Subject: UniStar Nuclear Energy, NRC Docket No. 52-016
Response to Request for Additional Information for the
Calvert Cliffs Nuclear Power Plant, Unit 3,
RAI No. 58, Seismic Design Parameters
RAI No. 63, Seismic Subsystem Analysis
RAI No. 65, Seismic System Analysis, and
RAI No. 112, Seismic Design Parameters

**Response Summary for Requests for Additional Information,
RAI No. 58, Seismic Design Parameters,
RAI No. 63, Seismic Subsystem Analysis,
RAI No. 65, Seismic System Analysis, and
RAI No. 112, Seismic Design Parameters
Calvert Cliffs Nuclear Power Plant Unit 3**

Response to NRC Request for Additional Information, RAI No. 58, Seismic Design Parameters, Question 03.07.01-9, and RAI No. 65, Seismic System Analysis, Questions 03.07.02-2, 03.07.02-3, 03.07.02-5, 03.07.02-7, 03.07.02-8, 03.07.02-11, 03.07.02-13, 03.07.02-17, 03.07.02-19, 03.07.02-20, 03.07.02-23, and 03.07.02-26, Calvert Cliffs Nuclear Power Plant Unit 3

Figure 1, Isometric View of UHS Makeup Water Intake Structure

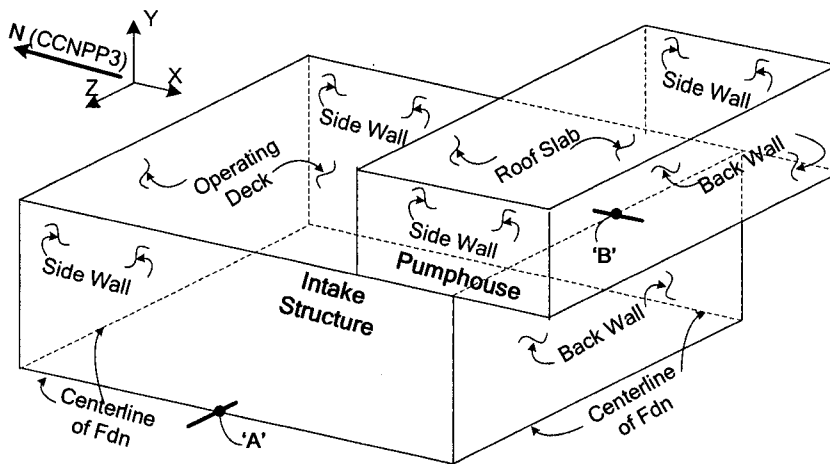
FSAR Section 3.7.2.3.2 states that the Ultimate Heat Sink Makeup Water Intake Structure is analyzed in GTSTRUDL. It further states that the walls "are not anticipated" to crack. Provide the basis for this statement including numerical results for typical concrete sections using the applicable wall design loads.

The Ultimate Heat Sink (UHS) Makeup Water Intake Structure is described below using a simplified sketch (Figure 1). The below-grade portion, referred to as the Intake Structure, has two side walls (North-South direction), one back wall (East-West direction) and an operating deck (interior walls not shown for clarity). The above-grade portion, referred to as the Pumphouse, located on top of the Intake Structure, has two side walls (North-South direction), one back wall and one front wall (East-West direction) and roof slab. As stated in the FSAR Section 3.7.2.3.2, the time history analysis is based on the un-cracked concrete section properties. FSAR Section 3.7.2.3.2 also notes that for the two North-South exterior walls (referred to as side wall of intake structure in this RAI response), cracking may occur during the SSE condition. However, overall impact to the global seismic response is determined to be insignificant. The results presented in this RAI response are based on the enveloped (seismic and non-seismic) loading conditions. It is also noted that the results due to seismic loading demands are based on conservative equivalent static method of analysis, where seismic accelerations obtained from the time history analysis are based on the peak values applied in-phase. It is demonstrated that different structural elements remain un-cracked for out-of-plane bending moment demands and shear demands. As noted in FSAR Section 3.7.2.3.2 and as indicated in the response to RAI 58 Question 03.07.01-9 (this enclosure), the use of un-cracked section properties in the seismic analysis will be verified by soil-structure interaction analysis using SASSI. Subsequent paragraphs of this response elaborate on the methodology to check the un-cracked condition of various structural elements and present numerical results.

For out-of-plane bending, the un-cracked condition of each structural element is verified by comparing the maximum moment demand (M_a) and the cracking moment (M_{cr}) per ACI-349-01 Section 9.5.2.3. The moment demand is calculated by adding absolute values of the out-of-plane bending (M_{xx} or M_{yy}) and normal twisting (M_{xy}) moments for the governing (seismic and non-seismic) load combination. The notation for the moment resultants is defined in FSAR Figure 3E.4-7. Numerical results of the verification are presented in Table 1 (Enclosure 3). For the north-south exterior wall only, results are presented for seismic and non-seismic loading combinations. For other structural elements, results are presented for the worst case loading condition.

For in-plane and out-of-plane shear, each structural element is verified by comparing the factored shear force (V_u) and the nominal shear strength (V_c) provided by concrete. Numerical results of the verification are presented in Table 2 (Enclosure 3). For the North-South exterior wall only, results are presented for seismic and non-seismic loading combinations. For other structural elements, results are presented for the worst case loading condition.

Table 1 and Table 2 (Enclosure 3) show that the values of (M_{cr}/M_a) and (V_o/V_u) , respectively, for each structural elements are greater than 1.0. Therefore, using un-cracked properties for the walls, deck and roof slab in accordance with ACI-349-01 Section 9.5.2.3 and ASCE 43-05 Table 3-1 as input in the GTSTRUDL finite element model for seismic analysis is appropriate.
